## Burned Propeller Hubs and Shaft Seals 3.0 Litre

MERCURY/MARINER  
1997 AND 1998, 225/250 HP, 3.0 LITRE  
S/N 0G438000 Thru S/N 0G693841

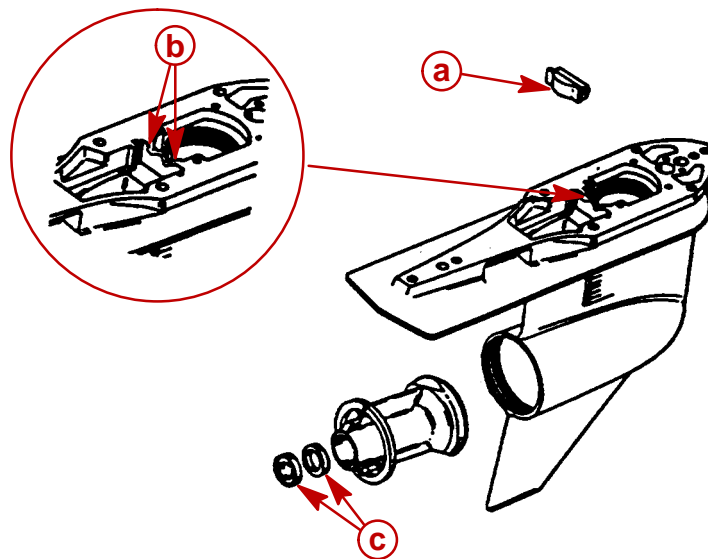
Some 3.0 Litre outboards have experienced low hour failures of burned propeller shaft seals, propeller hubs, gear case rubber filler blocks, and accelerated corrosion of the gear case, caused by unusually hot exhaust. These problems generally result from a lack of cooling water to the gear case caused by the following items.

- a** - Filler Block
- b** - Corroded Exhaust Dam
- c** - Propeller Shaft Seals

## HIGH SPEED PICK-UP PLATES P/N 17280A2

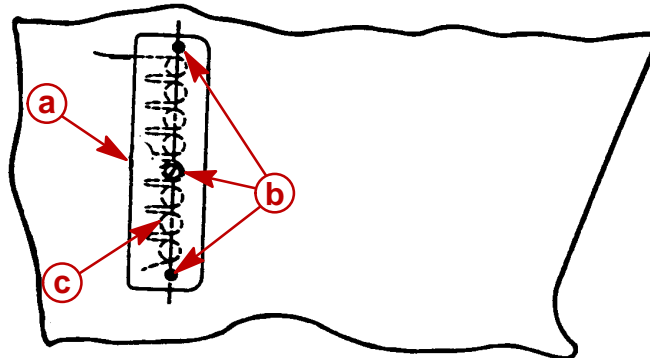
Installation of high speed pick-up plates may increase water flow and help cooling of the engines exhaust system and power head.

**NOTE:** The high speed pick-up plates have greater possibility of blockage from under water debris.

- a** - High speed pick-up plate P/N 17280A2
- b** - Mounting bolts (3)
- c** - Water inlet holes (8) each side

Install High Speed Pick-up Plates P/N 17280A2 on outboards between serial numbers 0G438000 and 0G693841 and assure that the outboard is properly mounted as follows.
